Product Change Notification

113218 - 00

Change Notification #: 113218 - 00
Change Title: Intel® Server System R2308GL4GS
PCN113218-00, Product Design
Update Resistors and Capacitors and 750W
Common Redundant Power Supply
FXX750PCRPS Firmware
Date of Publication: August 29, 2014

Figure 1. Component Locations for the 2U Riser Spare A2UL8RISER

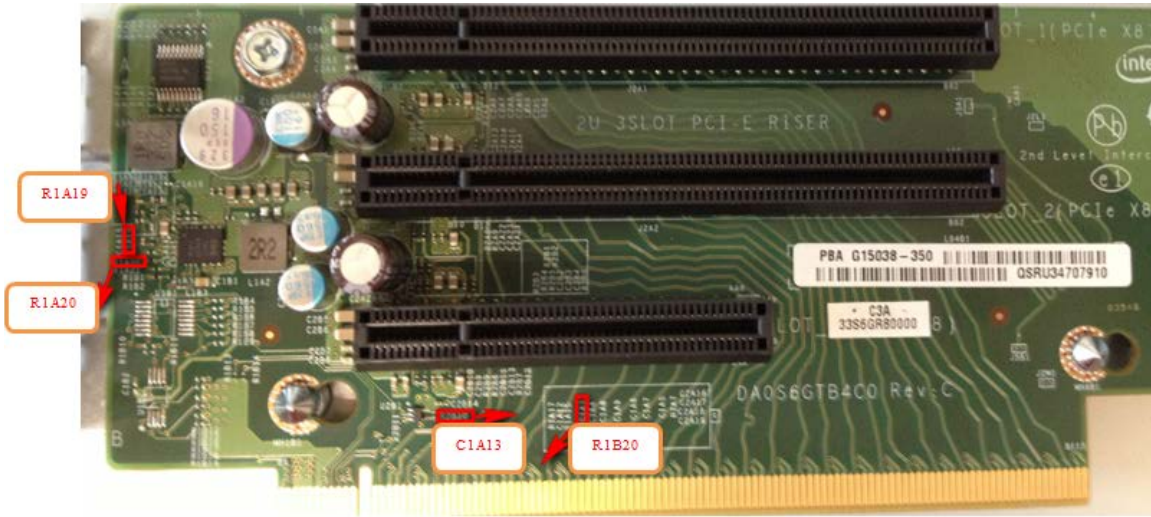
1. Update the following resistors and capacitor (see Table 1 and Figure 1) on the 2U PCIe Riser Spare A2UL8RISER to make an improvement to support a higher 3.3 Voltage Regulator startup over current. Before this change, the Voltage Regulator on the riser card may not be able to turn on when the total current drawn is more than 5A current. After this change, the Voltage Regulator on the riser card can support more than 10A current.

Table 1. Component Updates for the 2U Riser Spare A2UL8RISER

Component	Location	Pre-change	Post-change
Resistor	R2B10	10.0 kOhm	3.65 kOhm
Resistor	R1A20	0 Ohm	30 Ohm
Resistor	R1A19	40.2 kOhm	20 kOhm
Capacitor	C1A13	10 pF	120 pF
